Road & Bridge Design Publications

Monthly Update – November 2023

Revisions for the month of **November** are listed and displayed below and will be included in projects submitted for the **March** letting.

R-28-K

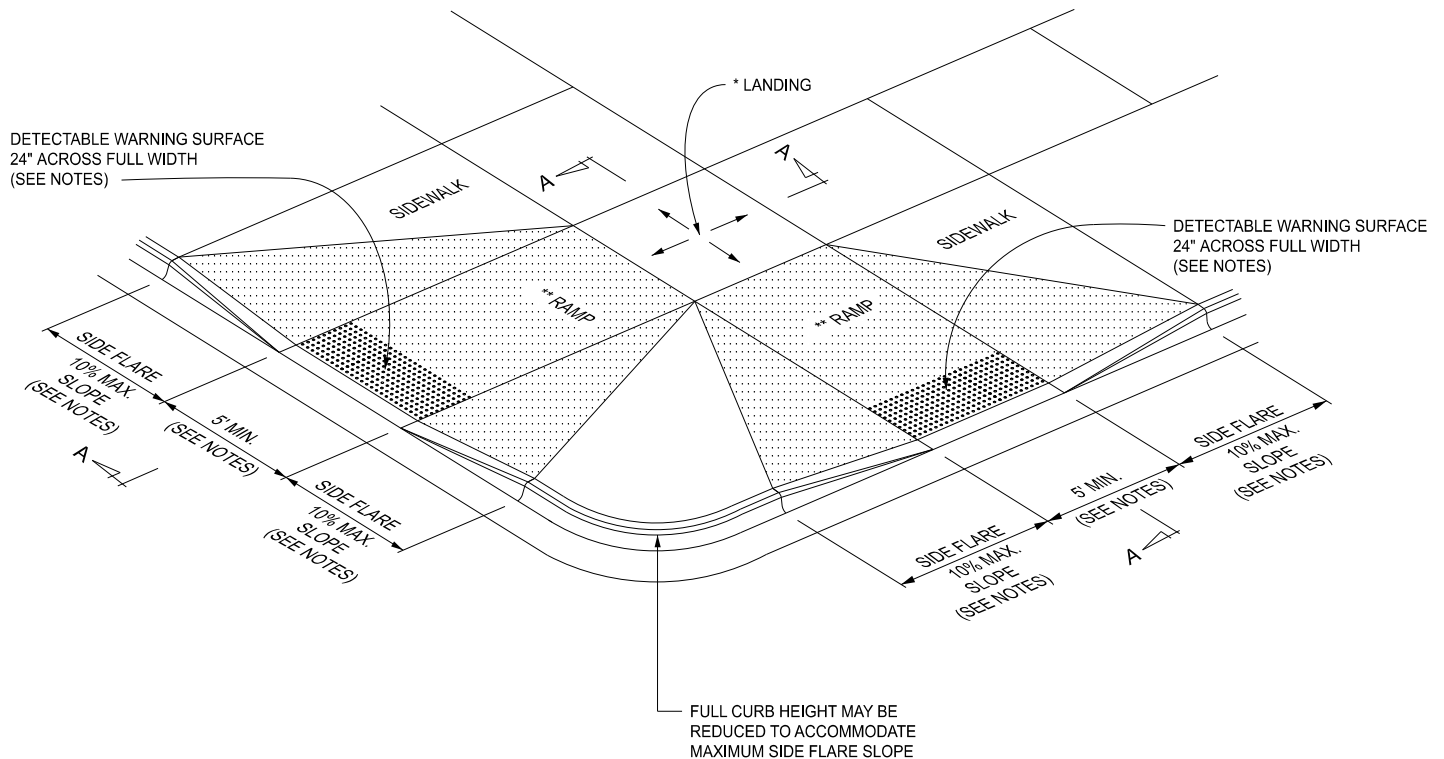
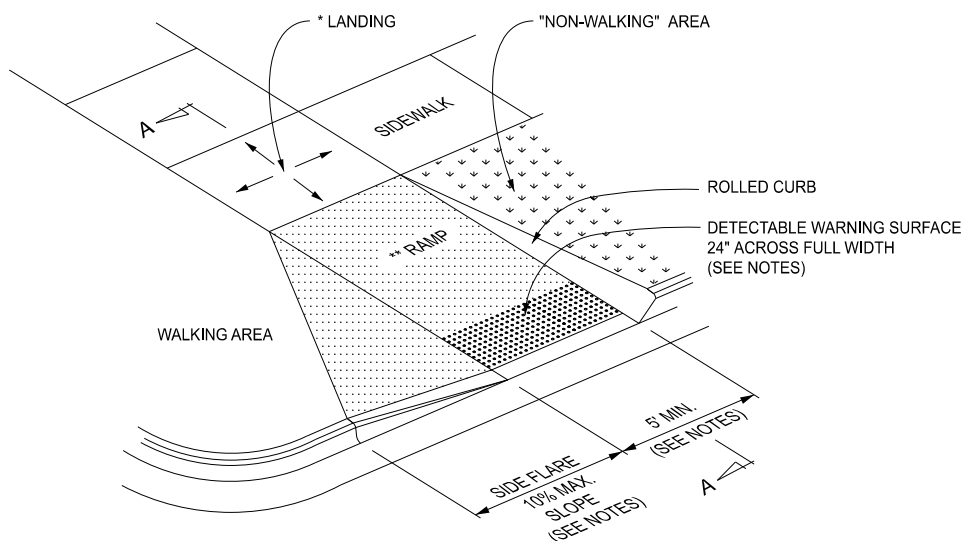
R-28-K: Curb Ramp and Detectable Warning Details: Revised the maximum sidewalk cross slope from 2% to 2.1% and the term “practicable” to “feasible” to match the final ruling of Public Right of Way Accessibility Guidelines (PROWAG).

* MAXIMUM LANDING SLOPE IS 2.1% IN EACH DIRECTION OF TRAVEL. LANDING MINIMUM DIMENSIONS 5' x 5'. SEE NOTES.

** MAXIMUM RAMP CROSS SLOPE IS 2.1%, RUNNING SLOPE 5% - 7% (8.3% MAXIMUM). SEE NOTES.

SHEET
2 OF 8

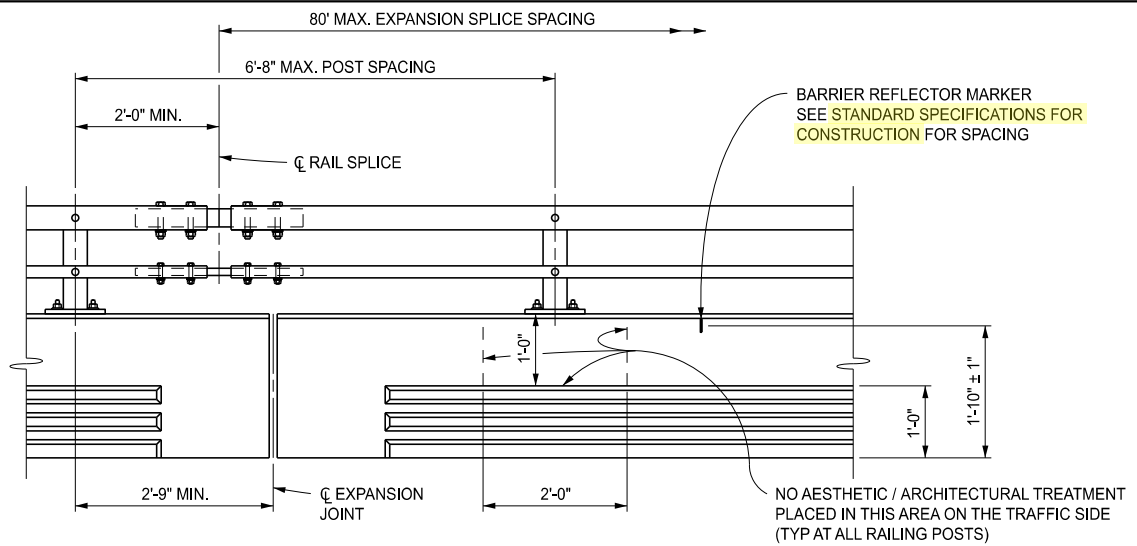
B-25-L: Bridge Railing, Aesthetic Parapet Tube: Revised the maximum sidewalk cross slope from 2% to 2.1% on sheets 2 & 7 to match the final ruling of PROWAG and removed the word current from Standard Specifications for Construction and AASHTO on sheets 1 & 3.

SHEET
1 OF 7

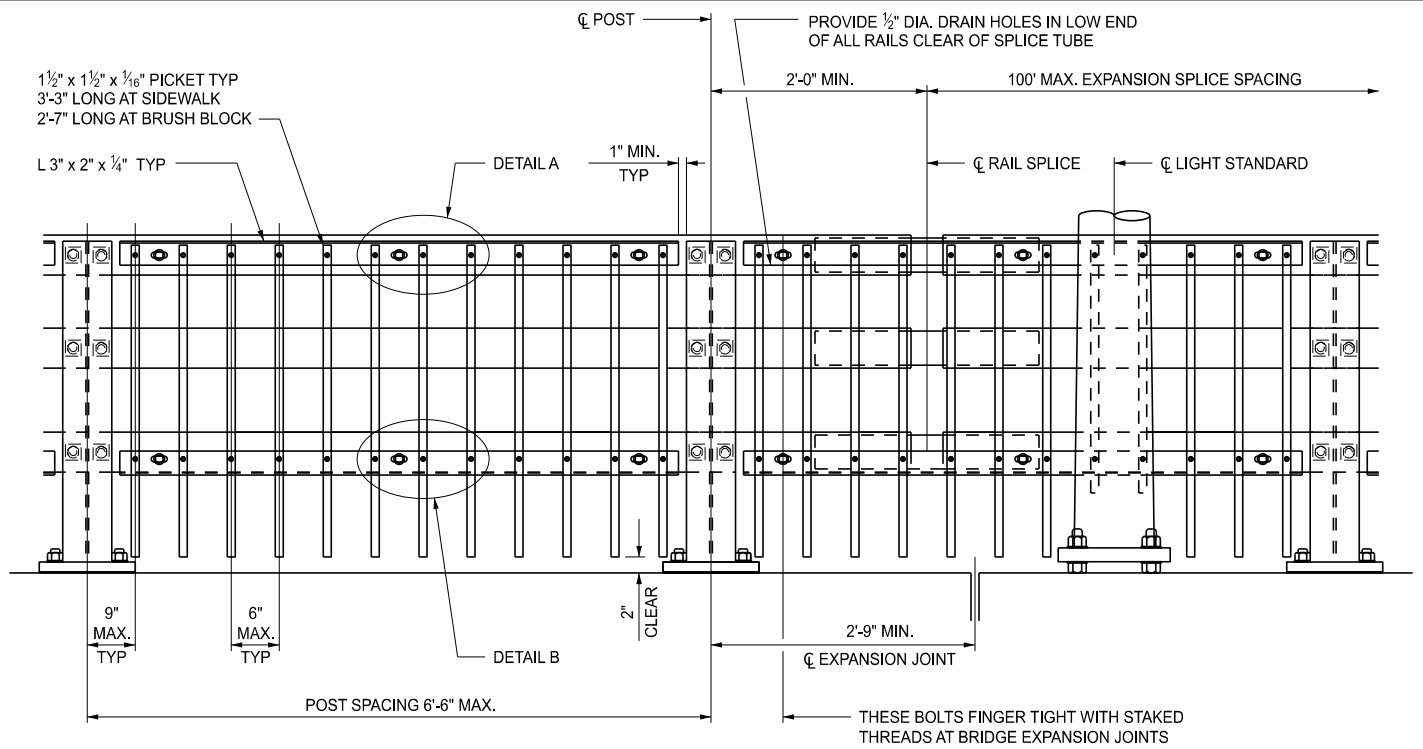
B-27-B: Bridge Railing, 3 Tube with Pickets: Revised the maximum sidewalk cross slope from 2% to 2.1% on sheet 1 to match the final ruling of PROWAG and removed the word current from Standard Specifications for Construction and AASHTO on sheet 7.
